DART AEROSPACE LTD	Work Order:	79019
Description: Crosstube High Aft (407)	Part Number:	D407-667-205
Inspection Dwg: D407-667-245 Rev: F		Page 1 of 1

DRAWING NO. D407-667-245	TITLE CROSSTUBE ASSY (407 HIGH AFT)	REV. F	DART AEROSPACE LTD ENGINEERING ORDER	D.E.O. NO. D407-667-245-F-1	SHEET NO. SHEET 1 OF 2	SCALE NTS
DRAWN <i>b</i>	CHECKED <i>q</i>	MFG. APPR. <i>8</i>	APPROVED <i>MD</i>	DE APPR. <i>MM</i>	DATE 11.04.12	DATE 11.04.12
DATE 11.04.08	DATE 11.04.12	DATE 11.04.12	DATE 11.04.12	DATE 11.04.12	DATE 11.04.12	DATE 11.04.12

DRAWING NO. D407-667-245	TITLE CROSSTUBE ASS'Y (407 HIGH AFT)	REV. F	DART AEROSPACE LTD ENGINEERING ORDER	D.E.O. NO. D407-667-245-F-2	SHEET NO. SHEET 1 OF 1	SCALE NTS
DRAWN <i>90</i>	CHECKED <i>ASS</i>	MFG. APPR. <i>ES</i>	APPROVED <i>MD</i>	DE APPR. <i>#</i>		
DATE 11.09.07	DATE 11.09.10	DATE 11.09.19	DATE 11.09.19	DATE 11.09.19	DATE 11.09.19

DRAWING NO. D407-667-245	TITLE CROSSTUBE ASSY (407 HIGH AFT)	REV. F	DART AEROSPACE LTD ENGINEERING ORDER	D.E.O. NO. D407-667-245-F-1	SHEET NO. SHEET 2 OF 2	SCALE NTS
DRAWN DATE 11.04.08	CHECKED DATE 11.04.11	MFG. APPR. DATE 11.04.12	APPROVED DATE 11/04/12	DE APPR. DATE 11.04.12

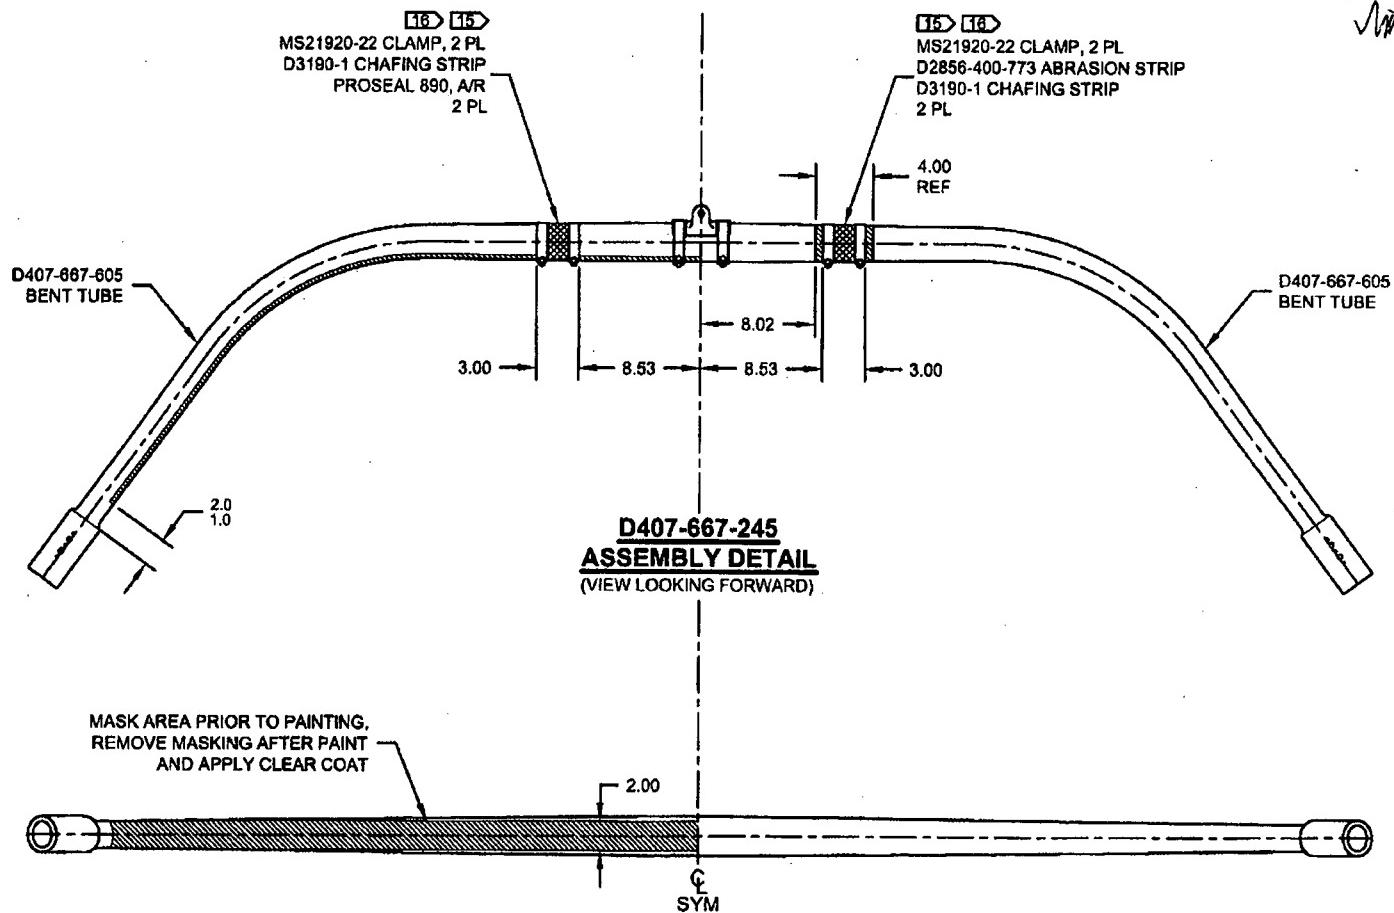
PURPOSE:

REMOVED ABRASION STRIP IN FAVOR OF A THIN LAYER OF PROSEAL 890.

NOTES 2 AND 15, SHEET 1 ARE AMENDED AS FOLLOWS:

- 2) FINISH: CHEMICAL CONVERSION COAT PER DART QSI 005 4.1
 PRIME INSIDE AND OUTSIDE PER DART QSI 005 4.2
 MASK UNDERSIDE OF CROSSTUBE AS SHOWN (HATCHED AREA) AND
 PAINT OUTSIDE PER DART QSI 005 4.2
 REMOVE MASKING AND APPLY CLEAR COAT
- 15) APPLY A THIN COAT OF PROSEAL 890 ON INSIDE CONCAVE SURFACE OF D3190-1
 CHAFING SHIELDS AND LET CURE PER MANUFACTURER'S INSTRUCTIONS. INSTALL
 PROSEALED D3190-1 CHAFING SHIELDS ONTO CROSSTUBE BY APPLYING A THIN COAT
 OF PROSEAL 890 ONTO CROSSTUBE. BE SURE TO ELIMINATE ANY AIR GAPS.

IS:WAS:RELEASED
2011-04-18
